### 3.4 Instrumentation and Control

The information in this section of the reference ABWR DCD, including all subsections, tables, and figures, is incorporated by reference with the following departure.

STD DEP T1 3.4-1 (Figure 3.4a, Figure 3.4b, Figure 3.4c)

Figure 3.4a Safety System Logic and Control (SSLC) ~~Control~~ Interface Diagram

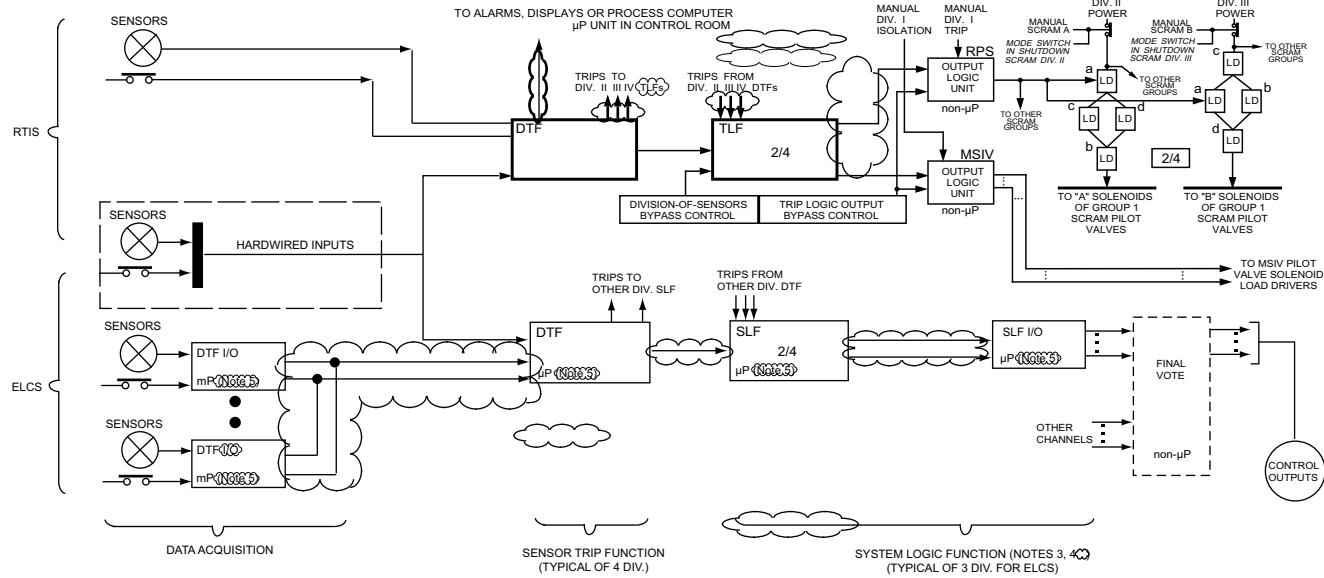
safety-related portions of the Neutron Monitoring System (NMS), the Containment Atmospheric Monitoring System (CAMS) and the radiation monitoring systems. The relationship between SSLC and systems for plant protection is shown in Figure 3.4a.

Figure 3.4b Safety System Logic & Control Block Diagram

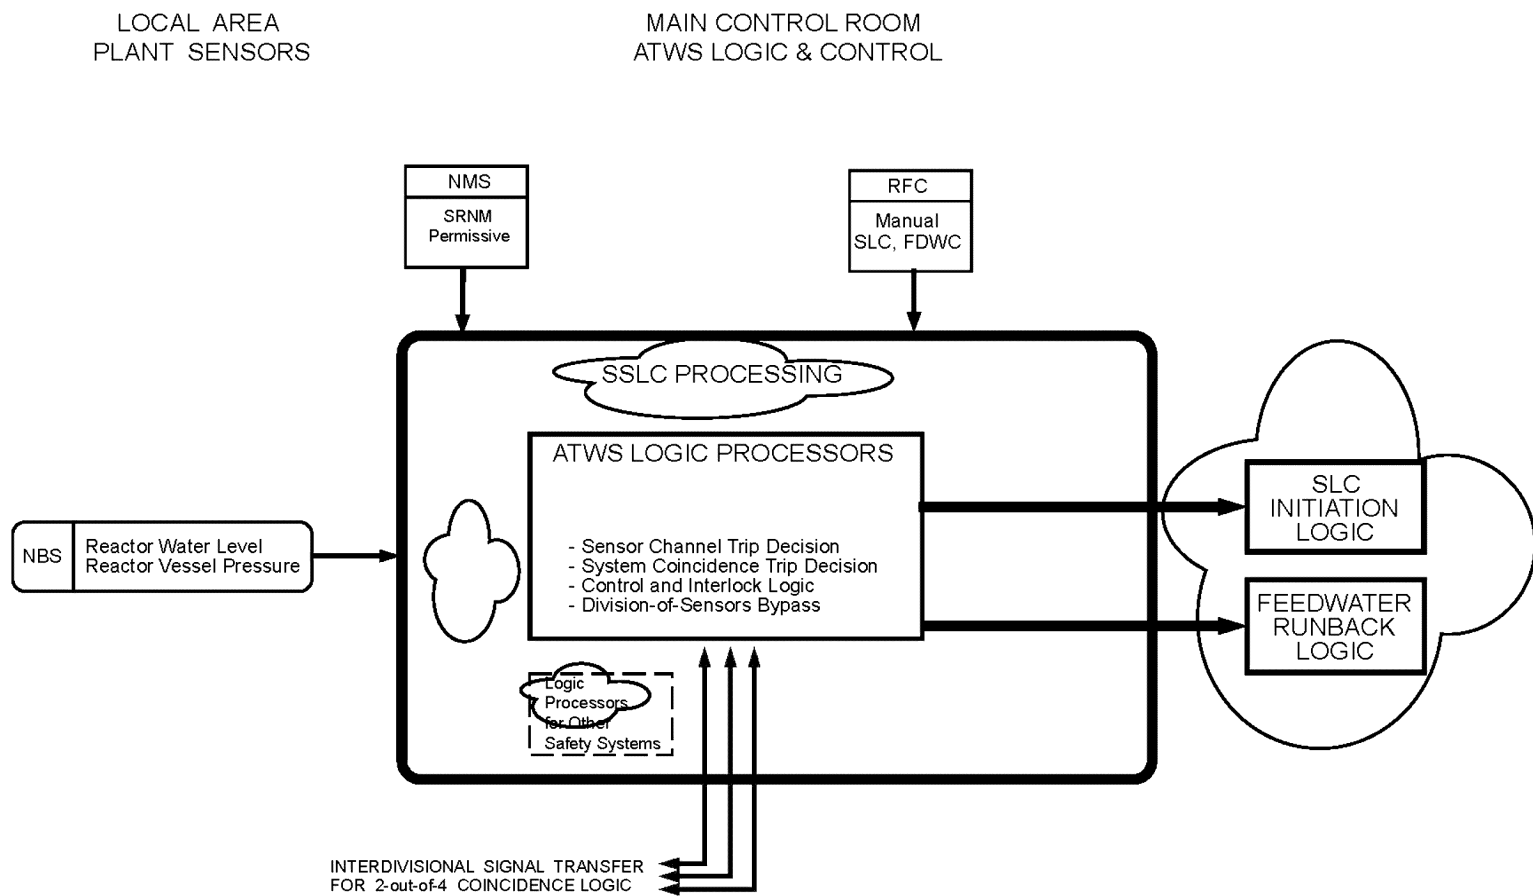
~~The basic hardware functional~~ configuration for one division of SSLC is shown in Figure 3.4b. Each division runs independently (i.e., asynchronously) with respect to the other divisions. The following steps describe the processing sequence and associated function descriptions for incoming sensor signals and outgoing control signals. These steps are performed simultaneously and independently in each of the four divisions:

- ALL SOLID LINE CONNECTIONS NOT EXPLICITLY IDENTIFIED CAN BE EITHER HARD WIRED OR FIBER OPTIC.
- SAFETY SYSTEM LOGIC FUNCTION (SLF) FOR ECCS FUNCTIONS IS IMPLEMENTED WITH REDUNDANT CHANNELS WITH A MINIMUM 2/2 VOTE OF THE OUTPUT SIGNALS TO PREVENT INADVERTENT COOLANT INJECTION OR DEPRESSURIZATION DUE TO SINGLE SLF ELECTRONICS FAILURE. THE OUTPUT VOTE MAY BE ACCOMPLISHED EITHER BY DIRECT VOTE OF SLF OUTPUT SIGNALS OR BY A SYSTEM VOTE WHERE BOTH VALVE AND PUMP ACTUATION IS REQUIRED TO INITIATE SYSTEM ACTION. BYPASS OF A FAILED SLF CHANNEL MAY BE PROVIDED AS LONG AS THE REMAINING OPERATIONAL CHANNELS PROVIDE A MINIMUM OF TWO SLF CHANNELS FOR ECCS FUNCTIONS.**

- SAFETY SYSTEM LOGIC FUNCTION (SLF) FOR SOME ISOLATION AND SUPPORTING ESF FUNCTIONS MAY BE IMPLEMENTED WITH REDUNDANT CHANNELS WITH A NORMAL MINIMUM 2/2 VOTE OF THE OUTPUT SIGNALS WHERE INADVERTENT ACTUATION OF THE FUNCTION MIGHT REQUIRE UNREASONABLY SHORT REPAIR TIMES TO ELIMINATE OPERATIONAL IMPACT. FOR THESE FUNCTIONS, OPERATIONAL CONTROLLED BYPASS TO ALLOW OPERATION WITH A FINAL 1/1 VOTE IS PERMITTED.**
